Re: In the Matter of Commonwealth Edison Company
(Byron Nuclear Power Station, Units 1 and 2)
Docket Nos. 50-454 and 50-455 OL

Response to NRC Letter Dated March 23, 1984

Response to NRC Letter Dated May 14, 1984

ATTACHMENT A TO RESPONSE
TO FINDING 3-7

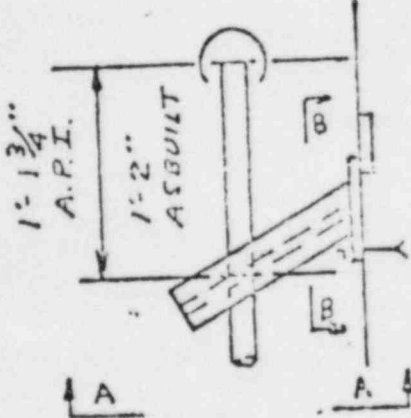
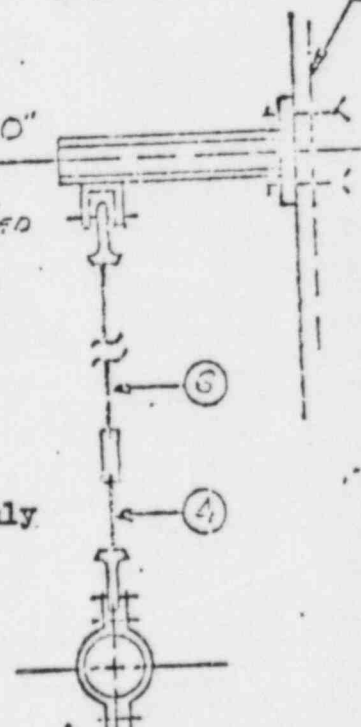
1. FCR F-9079
2. The backup calculation
3. Revision C to Support Drawing 1AF03009R"

Byron FCR F-9079 (dated 4-16-81) was written against Revision B of support drawing 1AF03009R to have a 1/4-inch overlap on its embedded plate. This FCR was picked up on Revision C of the drawing and issued on 12-23-81. Subsequently, this FCR was closed out on 1-9-82 as shown on Part D of the first page of the FCR.

FIGURE F4.1-1

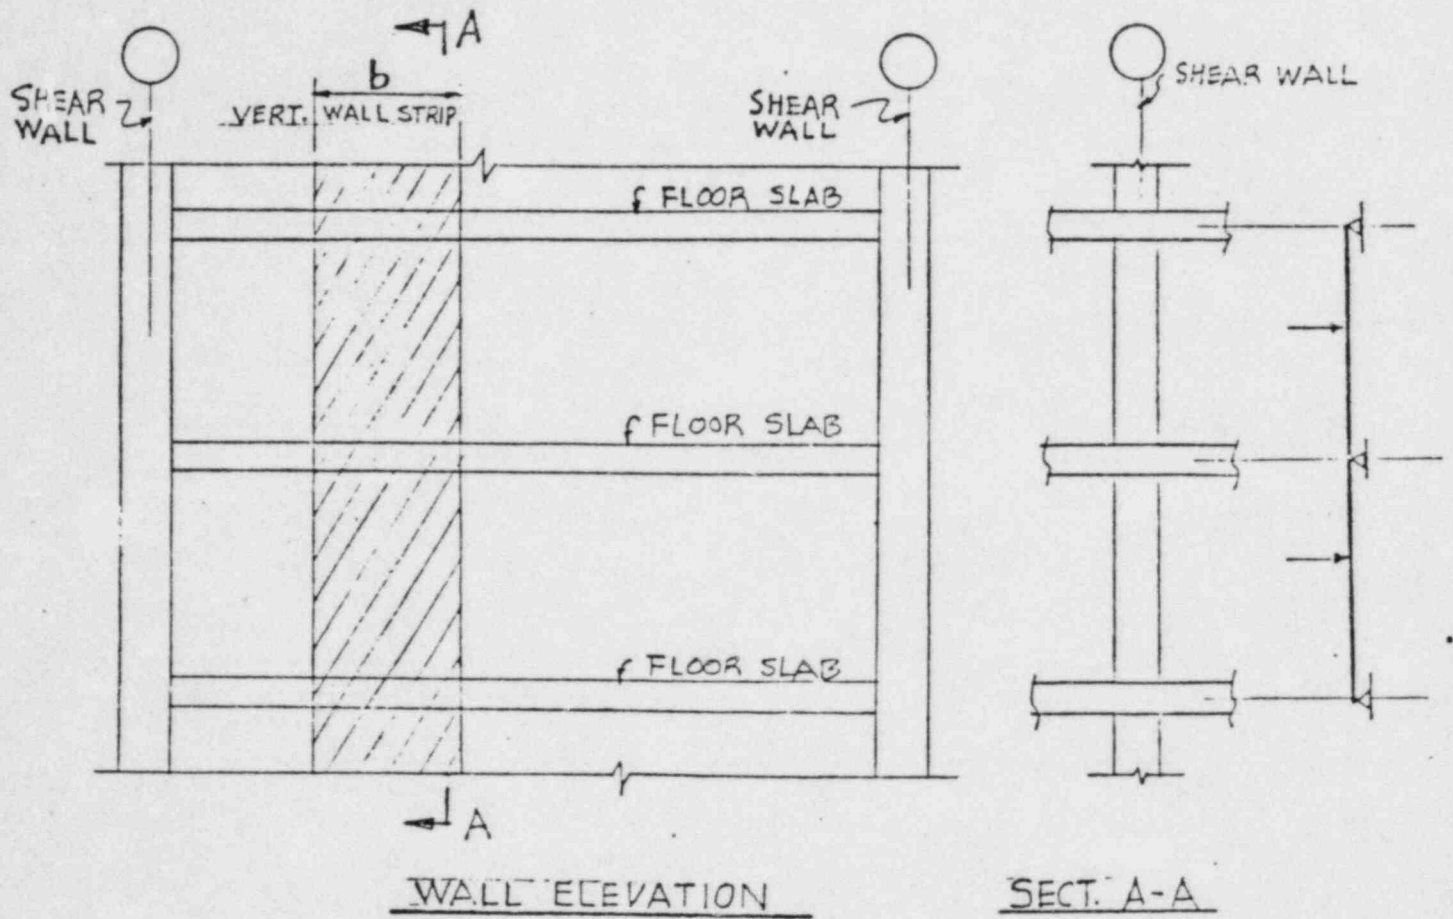
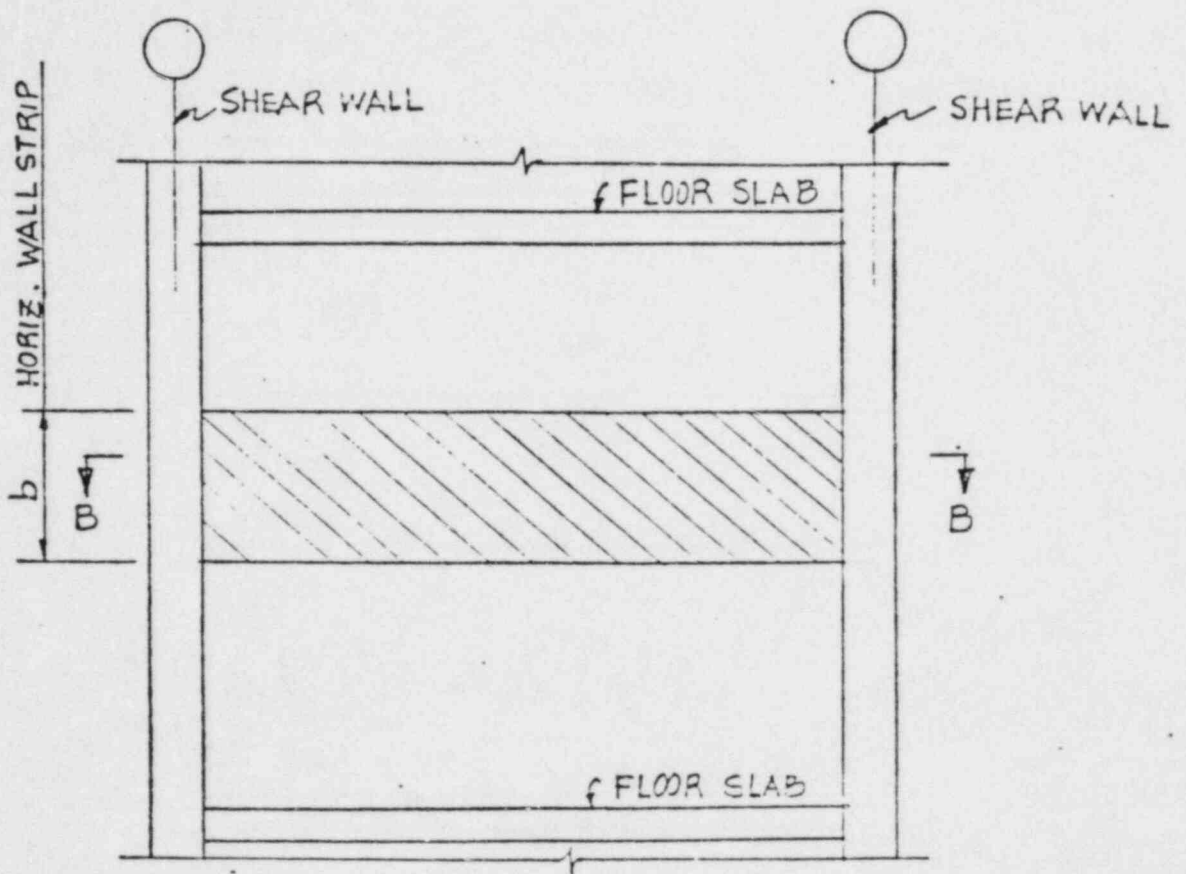
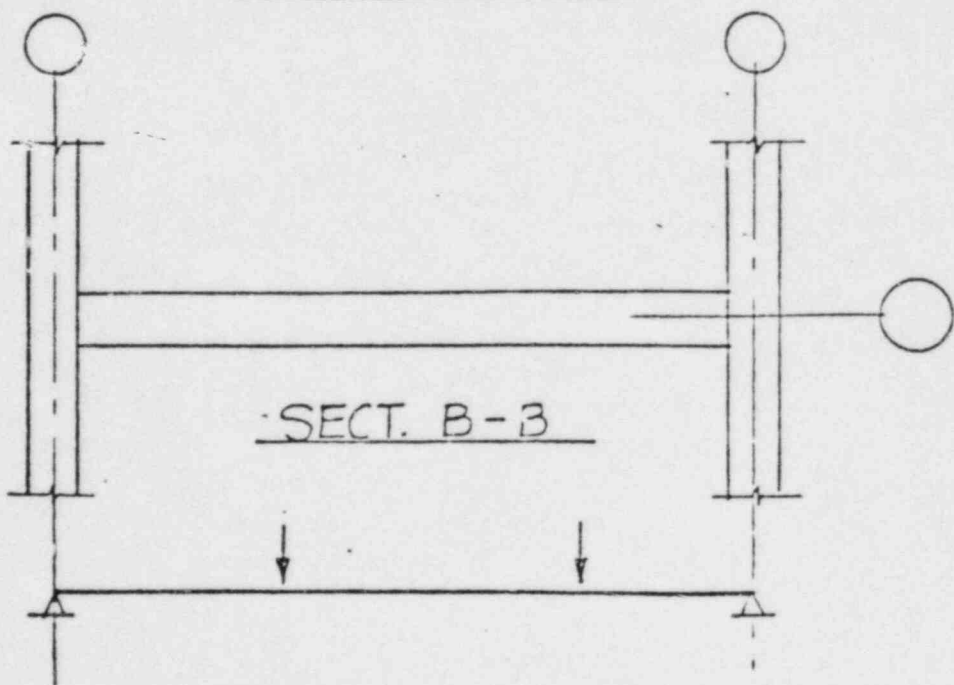
For a given wall loaded with a transverse wind load, describe how the transverse load at the center of a wall between two supporting orthogonal walls (shear walls) is carried out through the wall to the orthogonal walls which carry the shear force as in-plane shear in a normal shear wall concept. Describe how Sargent & Lundy determined the load capacity of the peripheral wall loaded transversely and converted these forces to stresses and then to reinforcing areas, if required. Describe how these same loads are addressed in the final load check. The use of diagrams to illustrate the details is recommended."

The transverse flexural steel area required for each wall strip was calculated using the flexural strength provisions of Chapter 10 of ACI 318-71. The transverse shear friction steel area required was calculated using the shear-friction provisions of Chapter 11 of ACI 318-71. Transverse loads are addressed in a similar manner in the final load check.

FIGURE U4.2-1*

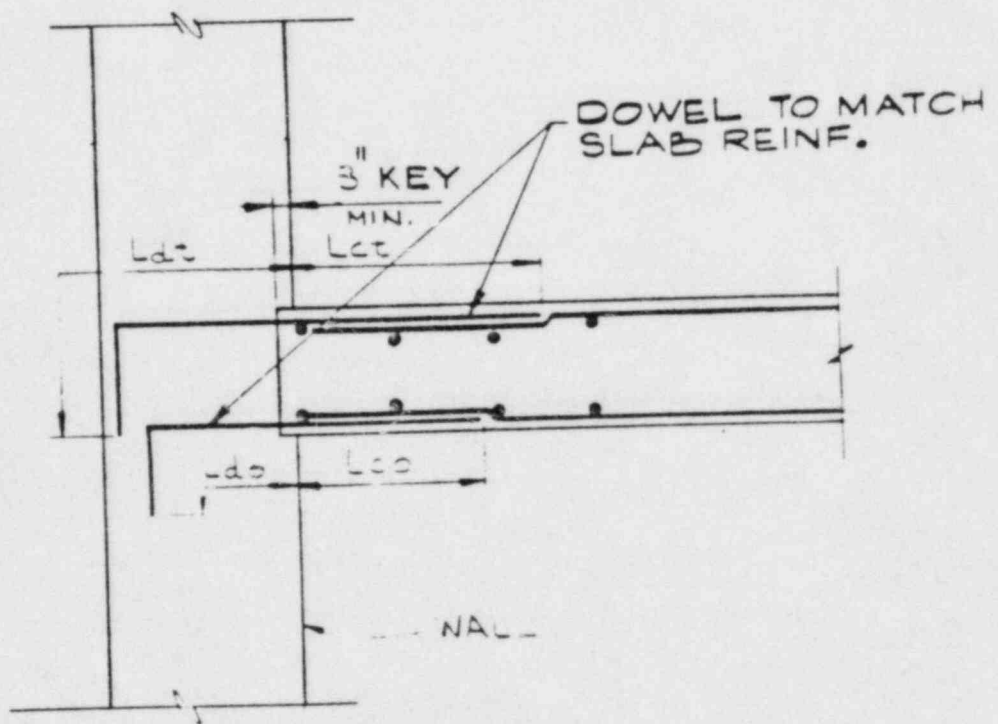
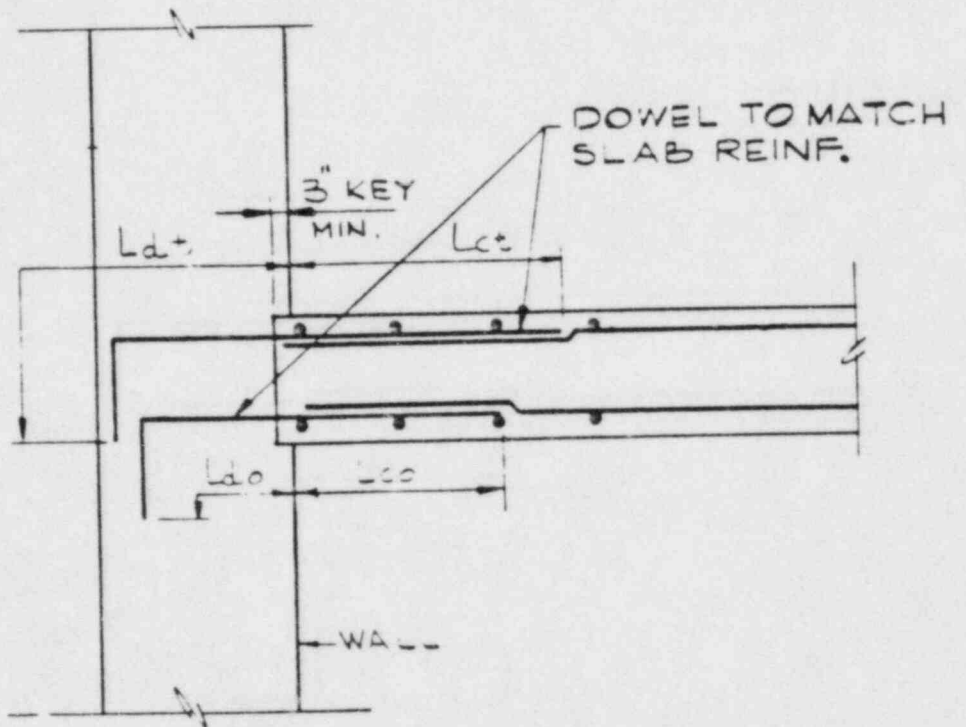
"The design procedure outlined in the response, if applied for all slab designs on the Byron project, would yield conservative steel areas (bottom steel) for midspan positive moments. You are requested to indicate whether this concept was used throughout the plant. Indicate if the procedure described in the original answer for supplying negative steel (top steel) at each slab boundary was used throughout the project and if so what portion of the maximum moment for a simply supported case was provided in negative moment capacity at the boundaries. Indicate, by providing detailed references to written documents, how these project-wide concepts (if used) were provided to individual designers in the way of instructions or procedures. If no project-wide concept was applied, indicate what technique was used in providing slab reinforcing based on varying boundary conditions."

As noted in our original response, negative moment steel equal to that at the continuous support was provided at the junction to the wall of slab 4AB53. This is a conservative design approach which was used for all slabs supported by walls. This typical detailing is shown as Slab Support Types 5 and 6 (see Figures U4.2-1 and U4.2-2) on Structural Drawing S-473 which was included in project Specification F/L 2722 and initially released to the appropriate contractors on August 7, 1974.

These standard details are specified for construction at all slab-to-wall junctions and, because they are standard details, no other reinforcing arrangements could have been used. Thus, their use is a project-wide concept and did not depend on the judgment of the individual designer involved.
